**ZONING AMENDMENT &
PLANNED UNIT DEVELOPMENT
STAFF REPORT**

Willie Shipman, Jr.

950 Baltimore Street and 1008 Marine Street
(Northwest corner of Baltimore Street and Marine Street)

PLANNING COMMISSION VICINITY MAP - EXISTING ZONING

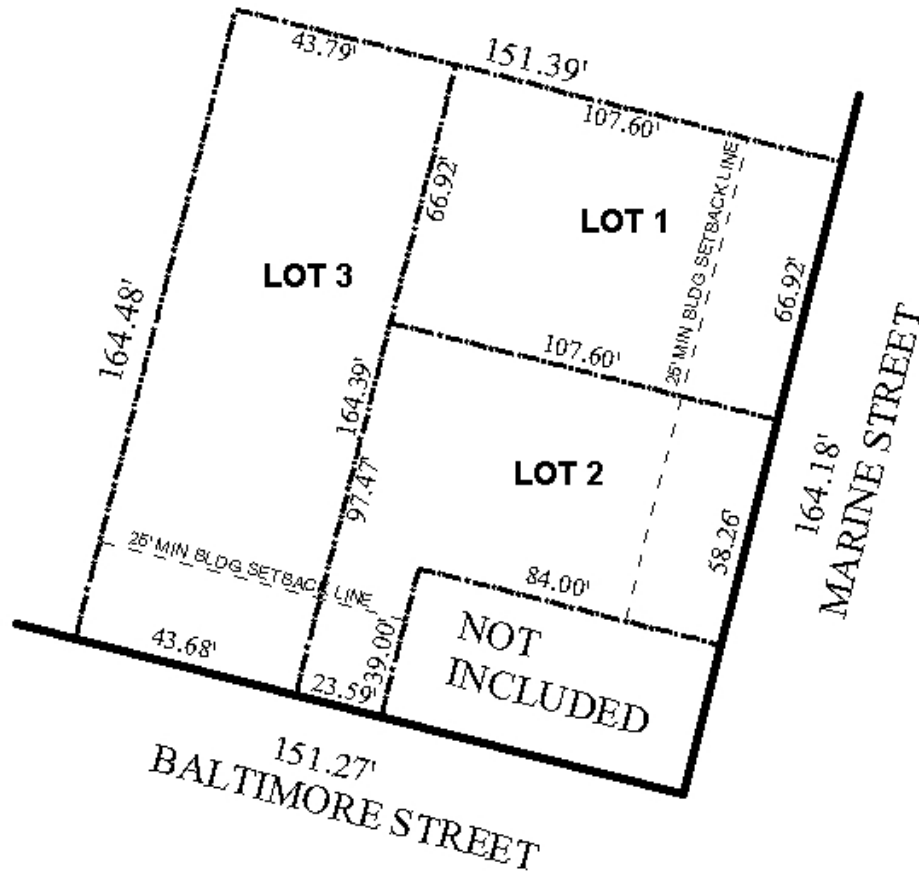
First, the legal description of the property, which defines the boundaries of the site, does not correspond to the site plans submitted by the applicant. The legal description of the property is reflected on the Vicinity Map and includes the vacant structure at the corner of Baltimore and Marine Streets, the existing duplex on Marine, a vacant lot north of the duplex, and an existing single-family residential structure on Baltimore Street. The site plan submitted for the rezoning is simply a copy of the recorded subdivision plat, and excludes the property at the corner. Furthermore, it does not illustrate any of the existing or proposed improvements. The site plan submitted for the PUD illustrates only illustrates the corner lot and the adjacent lot; it does not illustrate the overall site as defined in the legal description—it excludes the existing single-family home on Baltimore Street and the vacant lot on Marine Street.

PROPOSED PLANNED UNIT DEVELOPMENT SITE PLAN

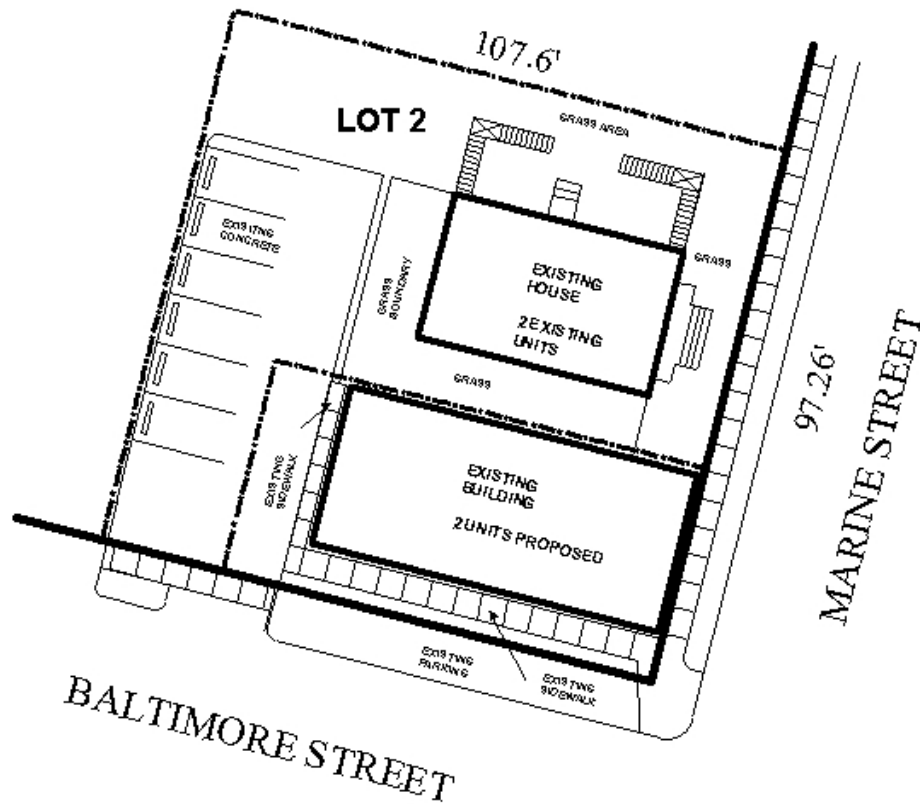
Driveway number, size, location and design to be approved by Traffic Engineering and conform to AASHTO standards. Parking aisles should be widened to twenty-four feet to accommodate traffic flow.

The most serious concern pertains to the proposed rezoning request. While PUD approval allows the overall site area to be calculated toward density requirements; even if the entire site as defined by the legal description was used, the site would not comply with R-2 density. Additionally, the proposed site plan does not illustrate adequate maneuvering area for the parking lot.

Rezoning and Planned Unit Development: Based upon the preceding, these applications are recommended for denial for the following reasons: 1) the site does not comply with R-2 density; 2) the site plans submitted do not correspond to the legal descriptions submitted by the applicant; and 3) the site plan does not illustrate adequate maneuvering area for the parking facility.
